1 Introduction

JMT Consulting has been commissioned by Atlassian (the Applicant) to prepare this document in response to the issues raised in by government agencies, community organisation groups and the public during the public exhibition of the proposed Atlassian Central State Significant Development (**SSD**) application (SSD-10405) in relation to the site at 8-10 Lee Street, Haymarket.

This document has been prepared to respond to the transport related issues raised by Transport for NSW and City of Sydney Council as reproduced on the following pages.

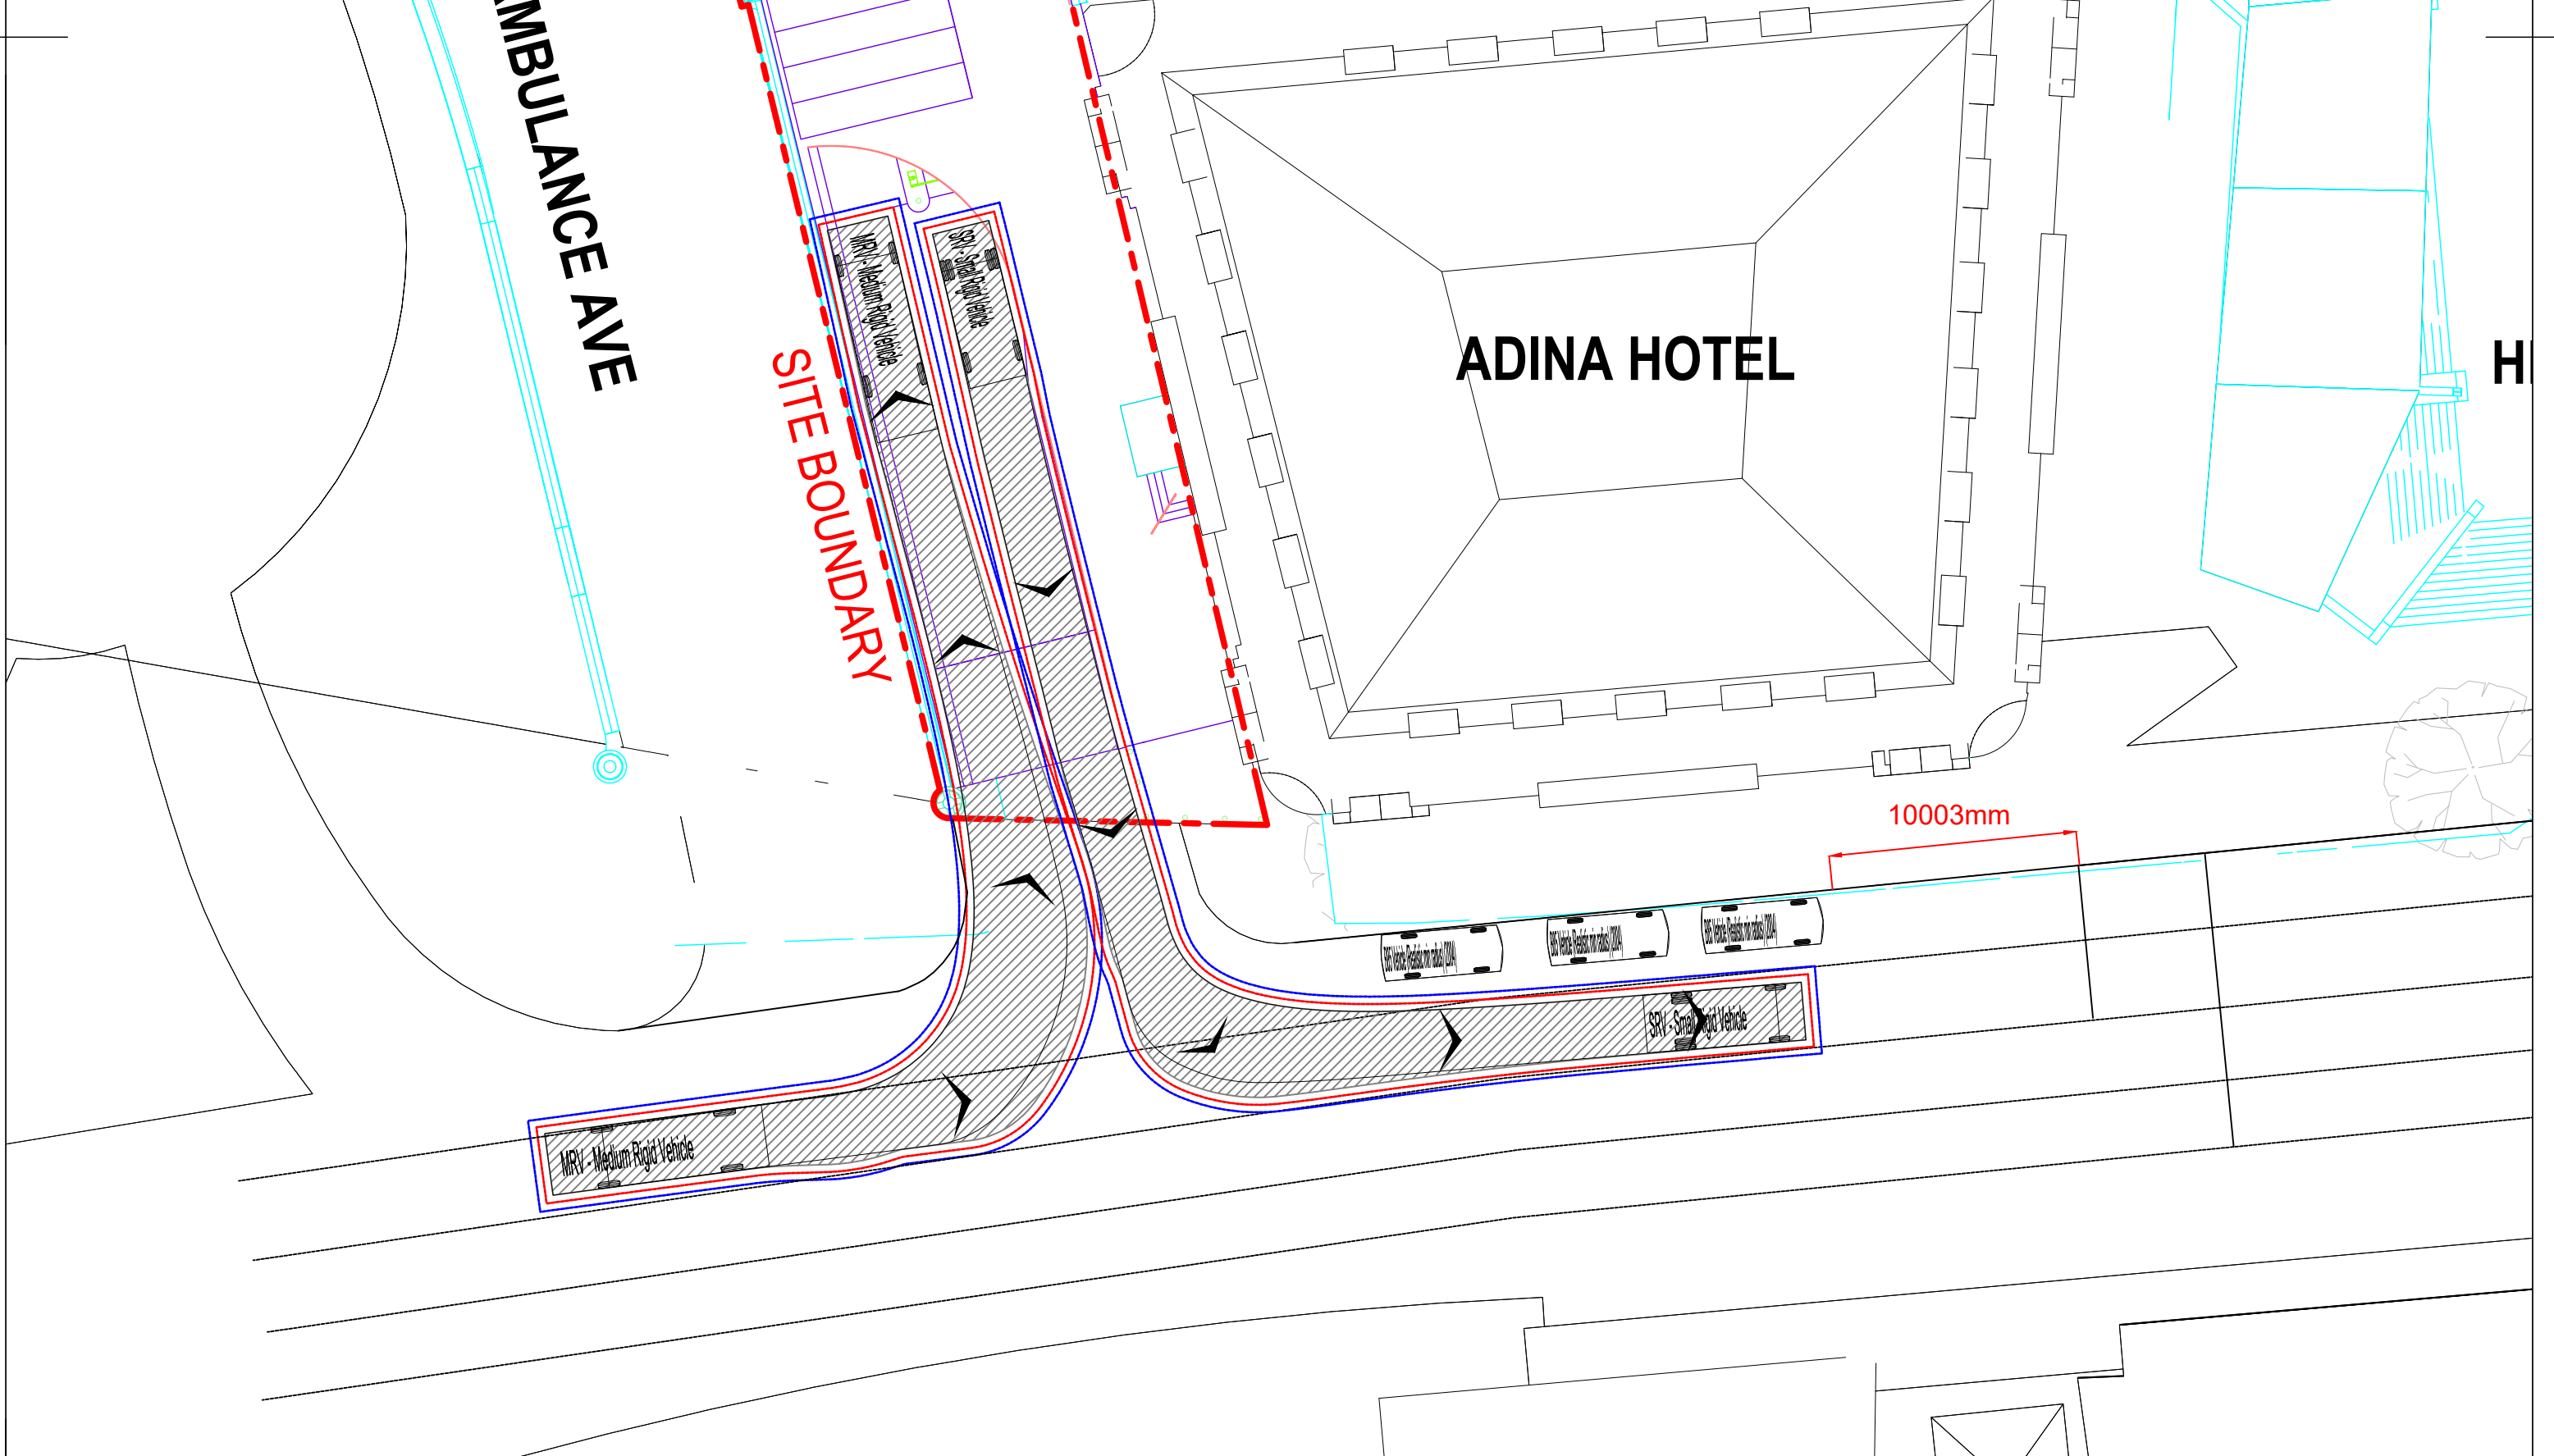
City of Sydney Council Submission	JMT Consulting Response
The application proposes a 3.6 metre clearance for the service vehicle ramp access. Please note that MRVs require 4.5 metre clear height and will have a maximum length of 8.8 metres. It is recommended that the ramp be amended accordingly.	The vehicle access ramp into the Atlassian building has been designed by JMT consulting to have the steepest possible ramp slope of 1:6.5, as per the Australian Standards requirements. As a result the lowest achievable RL for Level B2 is RL 5.0 which allows for the maximum possible height at the southern boundary connection. This ramp cannot be extended any further due to the turntable is at the bottom of the ramp. With the Sydney Water easement clearance zone a maximum clearance height of 3.6m for vehicles can be achieved which would be an extension of the dive ramp height. It is important to note that while a 3.6m clearance height is provided in the 'Day 1' scenario, suiting the specific needs of Atlassian, a 4.5m clearance height is provided in the 'Day 2' scenario which satisfies the requirements of all stakeholders in the Western Gateway precinct. A 4.5m clearance height for a Medium Rigid Vehicle (MRV) is noted in Table 2.1 of Australian Standards for off-street commercial vehicle facilities AS2890.2 2018. In relation to this clearance height the following should be noted: • The reference to a 4.5m clearance height is based on specifications a document from 1995 that has since been withdrawn • The standard notes that there is provision for a variation in the dimensions when a commercial facility is being designed specifically for a nominated vehicle type. The Atlassian Central development dive ramp structure via Lee Street has been designed to provide a 3.6m clearance height which will initially service the on-site loading dock, prior to the completion of the Dexu/Frasers Site. Given the constraints associated with the Sydney Water asset above the B2 access tunnel, a 3.6m height clearance to service the Atlassian Central development would be considered acceptable. As indicated in the table below, there are

A 3.6m height clearance provides flexibility for a large range of Medium Rigid Vehicle's including waste contractor vehicles with a lifting capacity of over 600kgs and payload of 8500kgs. An example of a large rear-lift waste contractor vehicle with a clearance of less than 3.6m is shown in the figure below.

Drawing No
SKT24

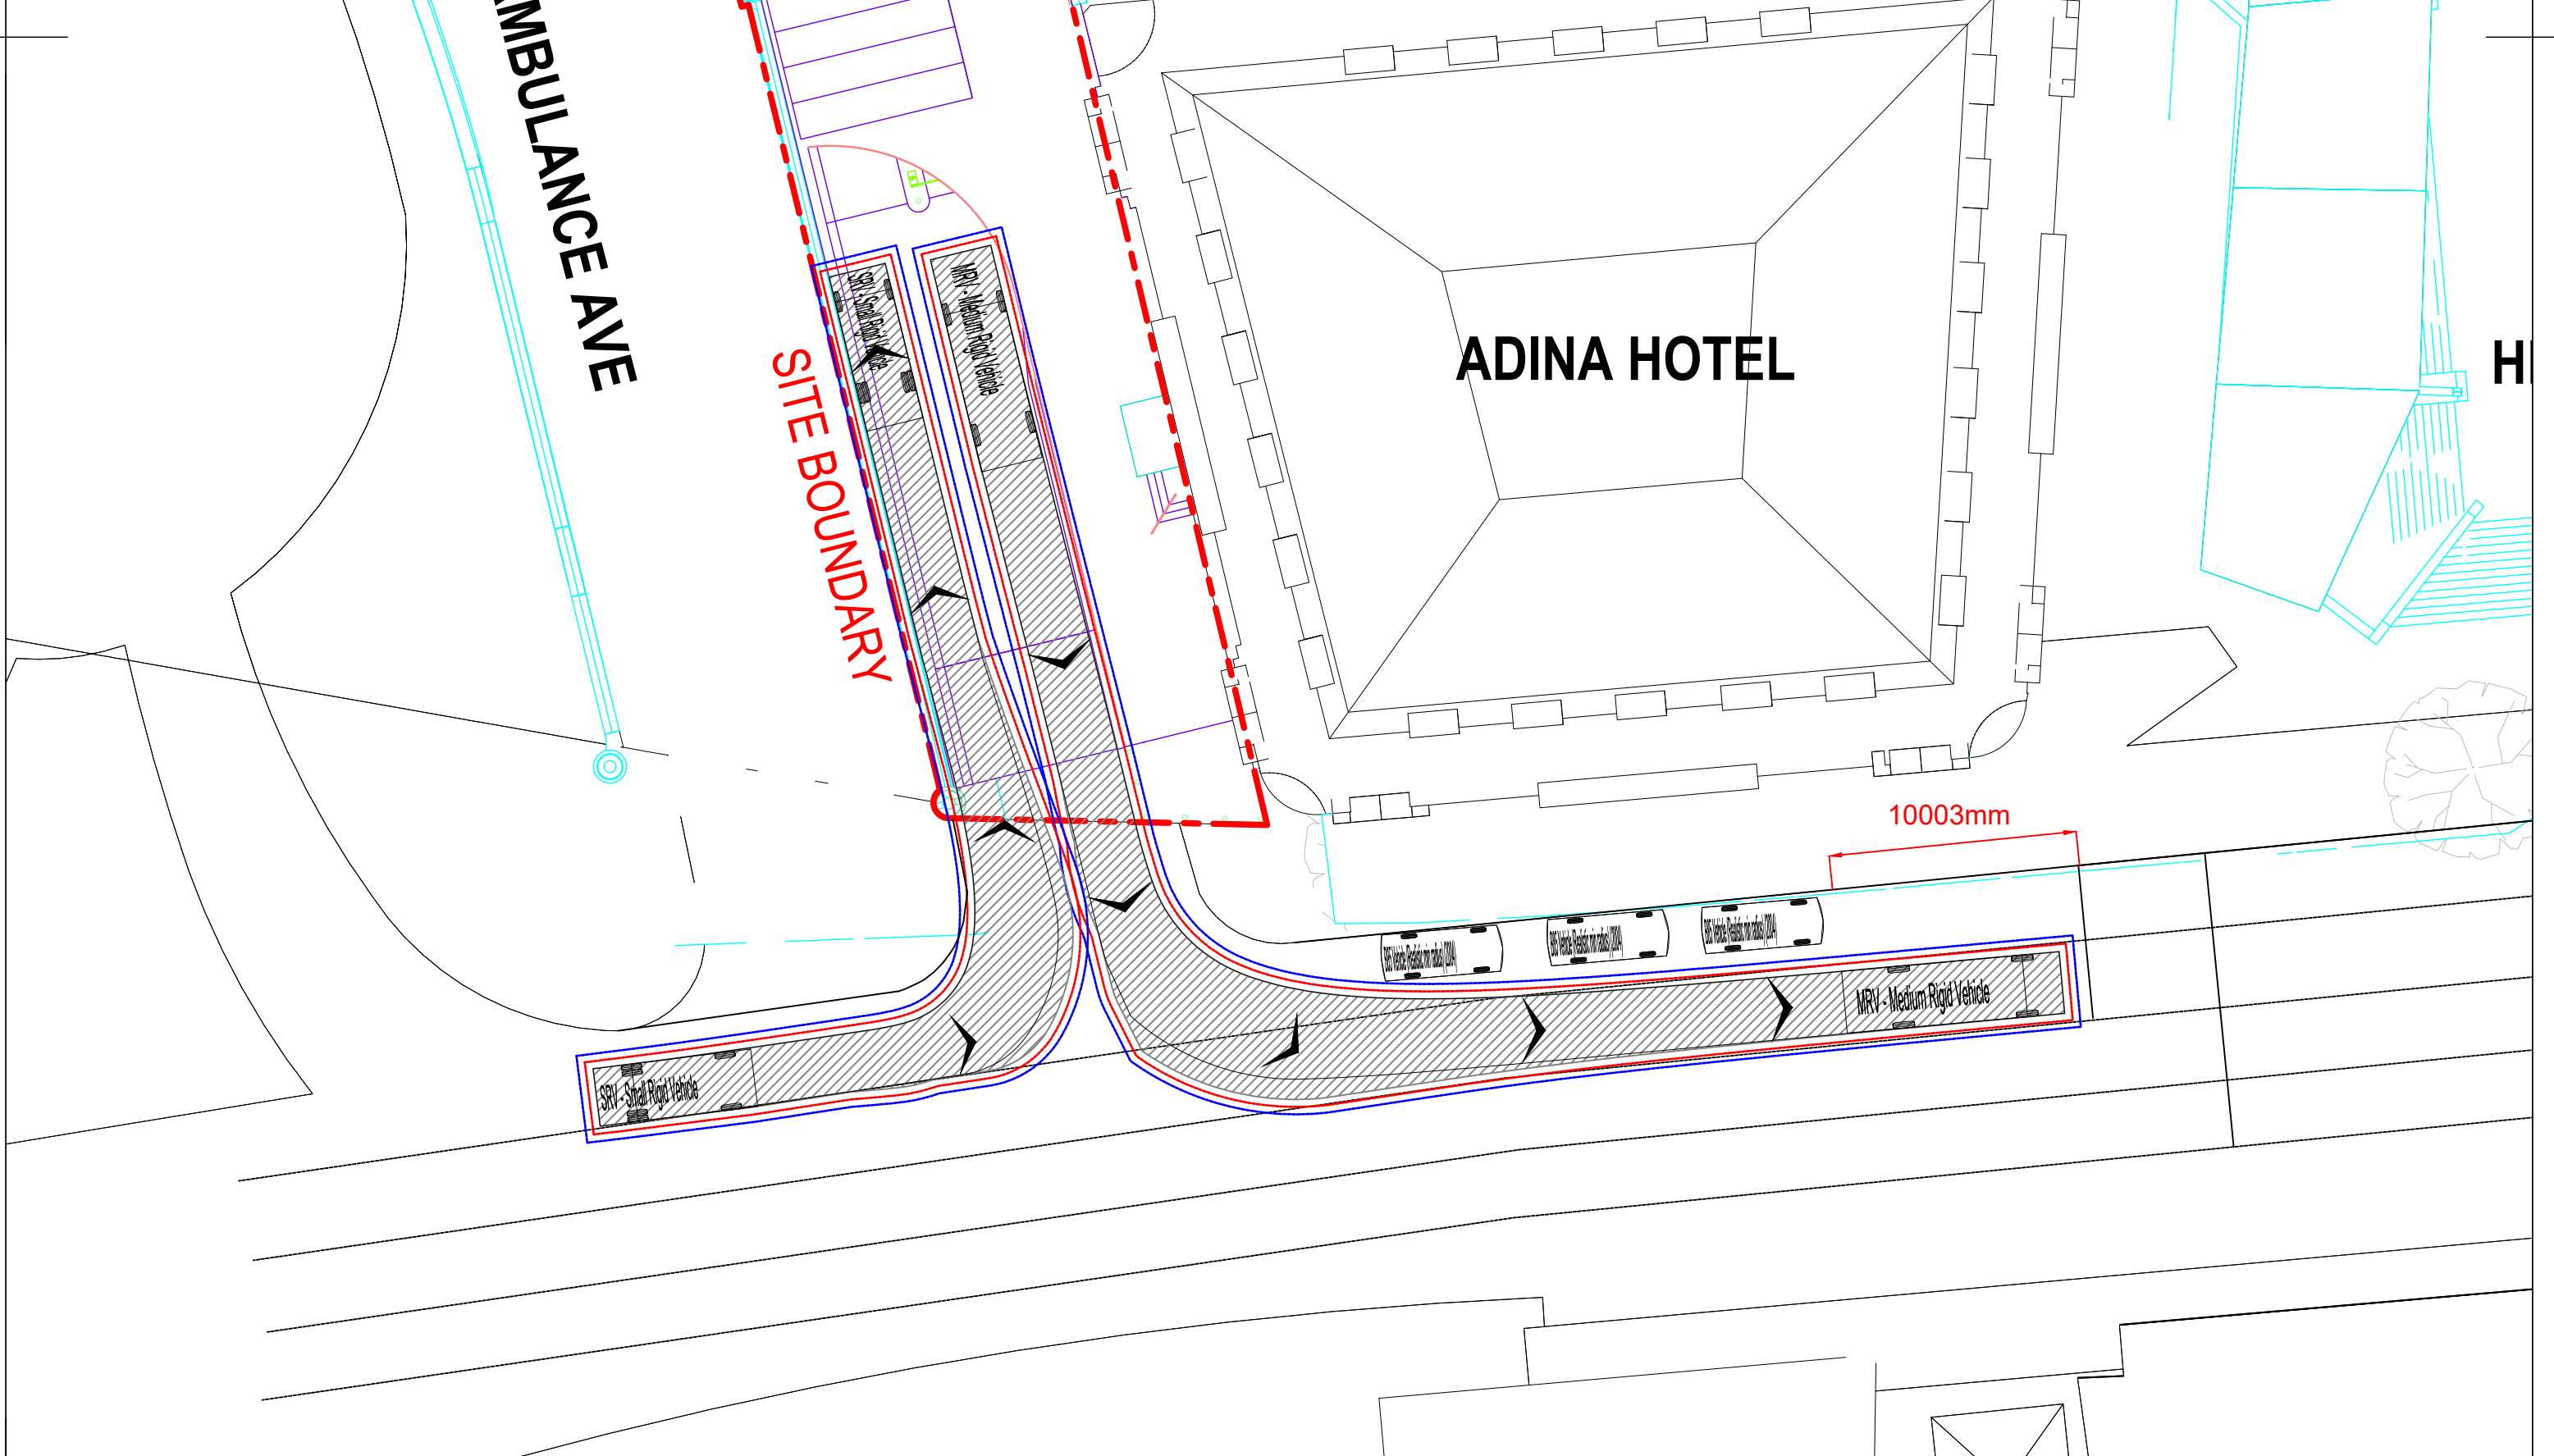
Transport for NSW Submission	JMT Consulting Response
Austroads Guide to Road Safety Part 6: Managing Road Safety Audits and Austroads Guide to Road Safety Part 6A: Implementing Road Safety Audits by an independent TfNSW accredited road safety auditor; and A Swept Path analysis for the simultaneous service vehicle movements to/from Lee Street through dive ramp structure for the maximum size of the vehicle that would expect to use the loading dock. Swept paths need to cover the vehicle travel paths between Lee Street and the loading dock. Based on the results of the road safety audit and the swept path analysis, the design drawings need to be reviewed to identify safety measures that may need to be implemented in consultation with TfNSW.	great detail the Lee Street driveway design and layout. Importantly it has been demonstrated through the additional swept path analysis that vehicles are safely able to enter and exit the site. The Lee Street driveway design will be further developed during the detailed design phase of the project well before construction commences. Therefore this point in the project will present a more suitable time to undertake the RSA in accordance with the TfNSW recommendation, with the findings and recommendations of the RSA to be incorporated in the final drawing set for the project. This requirement to undertake a RSA prior to the commencement of construction may be reinforced through a suitably worded condition of consent. At this stage it has been demonstrated however that the current driveway design provides for suitable width to accommodate simultaneous vehicle entry and exits to the site without impacting the flow of traffic on Lee Street. The dive ramp has been designed to provide for a 1:20 gradient at the top of the ramp so vehicles have excellent sight lines to oncoming pedestrians as they exit the site. The level of vehicle movements into the site is low at less than 1 vehicle every 4 minutes and this volume of traffic, coupled with the driveway design, will not impact pedestrian safety. The existing pedestrian refuge adjacent to Ambulance Avenue would be removed in conjunction with the closure of Ambulance Avenue to vehicle traffic. A continuous footpath treatment will be provided on the northern side of Lee Street to emphasise pedestrian priority at this location.
